# APPLICATION TO ALTER, REPAIR, Etc.

1. State how many buildings to be altered. one
2. What is the street or avenue and the number thereof? Give diagram of property. No 152 Avenue A, bet. 11<sup>th</sup> & 12<sup>th</sup> Street.
3. How much will the alteration cost? \$ 1800.

Amendment to application #1041, alteration, 1897,  
is disapproved, with the following objection: viz.,-

Amendment to Application No. 1041 Alt of B. 1897

ELEVATION OF FRONT PIERS.

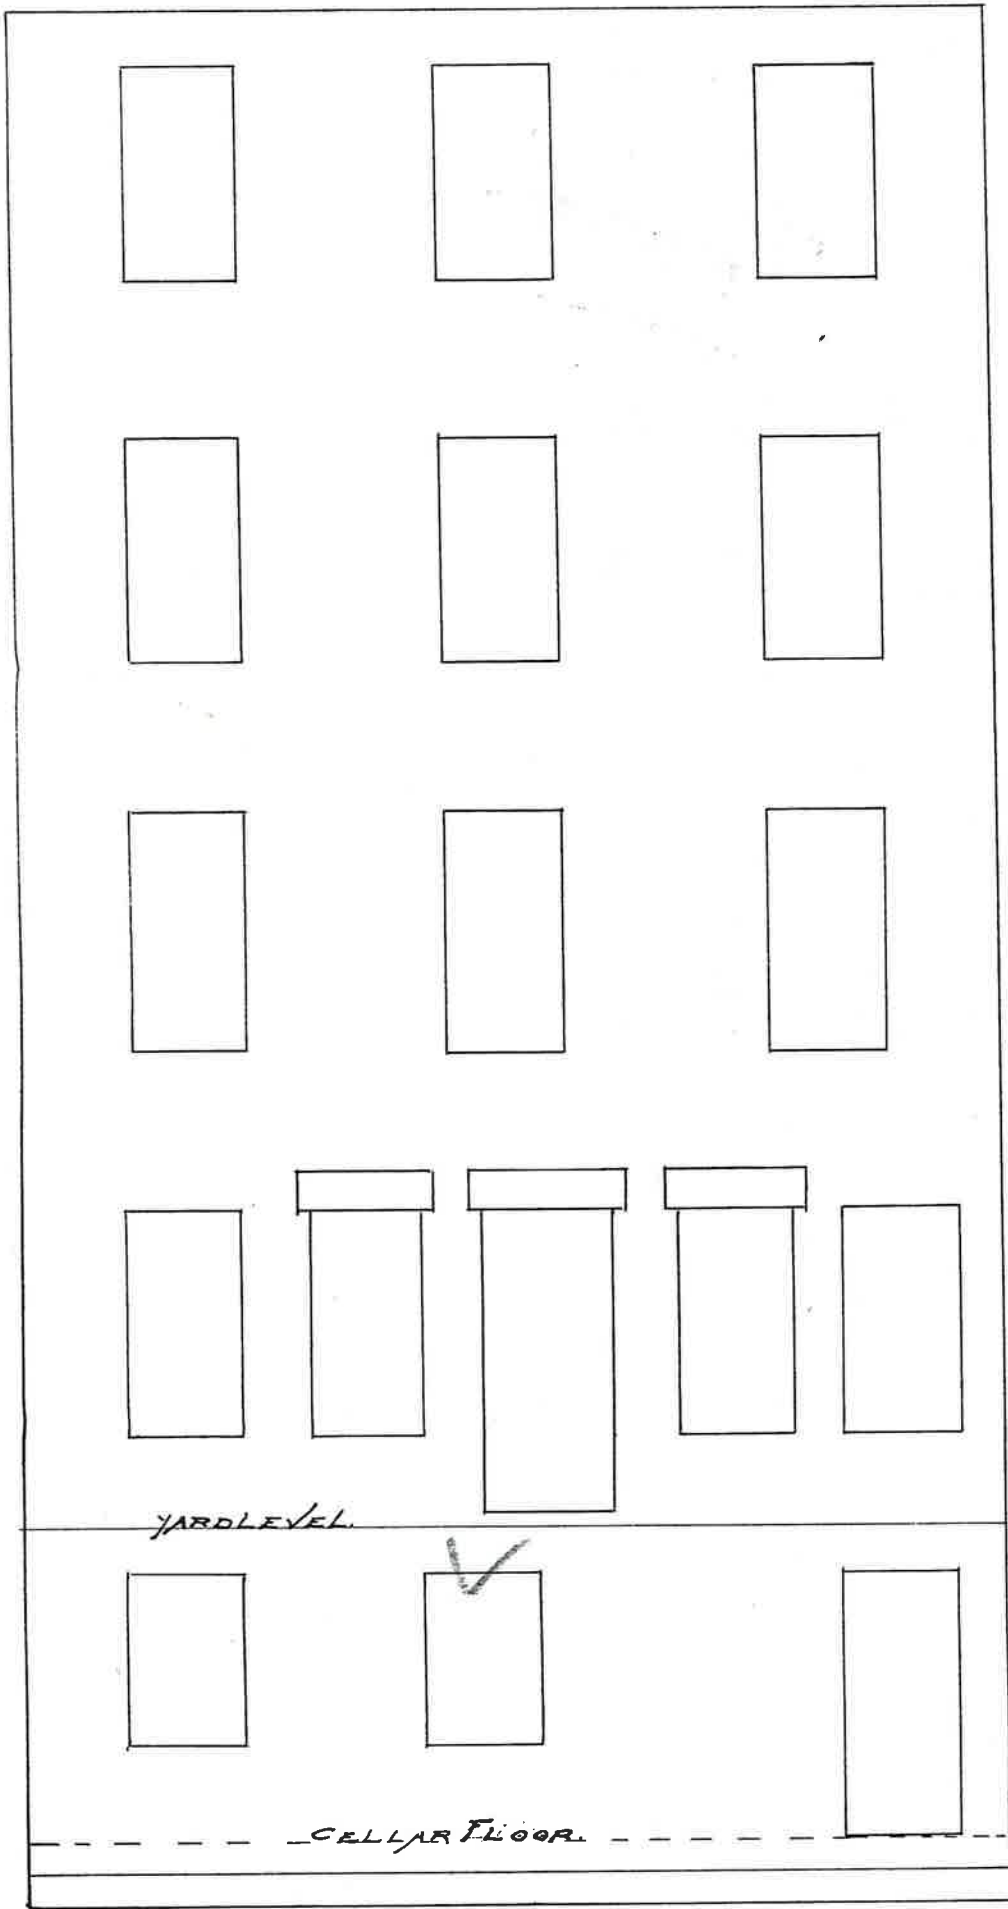
- ✓ 1. The piers under end posts are too small.
- ✓ 2. The piers under front wall posts, must be braced  
latterly at 1st tier.
- ✓ 3. The footings under front wall piers must be shown.
- ✓ 4. An elevation of rear wall must be filed.

- 1) Piers under end posts will be made same size as under centrepasts, 16" x 20"
- 2) Piers under front wall posts will be braced laterly at first tier as shown by water tables, sills etc.

Footings under front wall piers are now shown.
